OSHTEMO CHARTER TOWNSHIP ZONING BOARD OF APPEALS

MINUTES OF MEETING HELD JUNE 16, 1997

AUTOMOTIVE WERKS - SITE PLAN REVIEW - PROPOSED 10,000 SQ. FT.  
AUTOMOTIVE REPAIR CENTER - UNIT #5, SEECO COMMERCIAL PARK

MAPLE HILL CHRYSLER - VARIANCE FROM LIGHTING STANDARDS - 5612 WEST  
MAIN

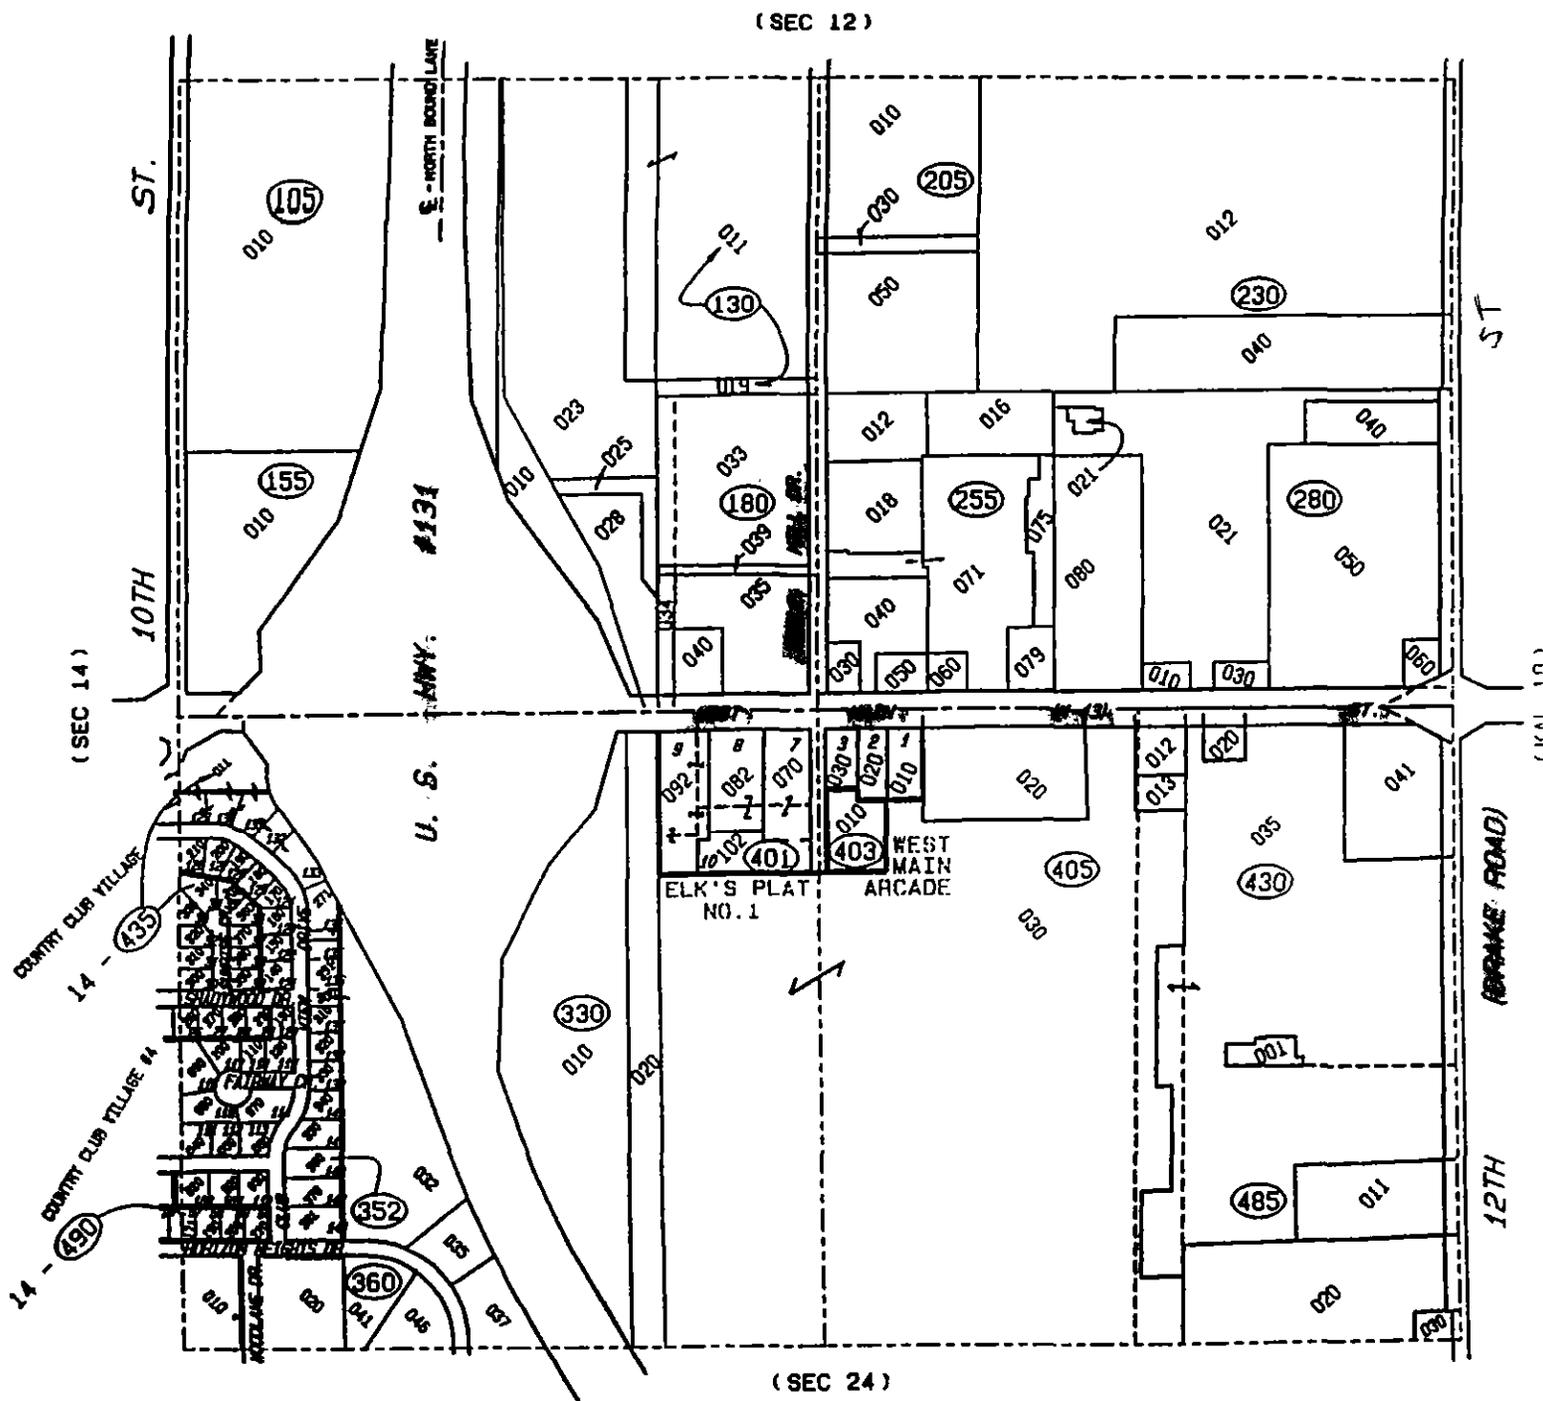
: The previous lighting arrangement on the subject site was legally nonconforming. As a nonconforming arrangement, alterations and/or improvements to the lighting system shall occur only in compliance with existing Ordinance standards.

: The ability to comply with Ordinance footcandle standards at the site perimeters is limited due to parking lot proximity to site perimeters and the recommended footcandles for parking lots.

The subject site and parking lot layout were both established prior to the adoption of the lighting standards.
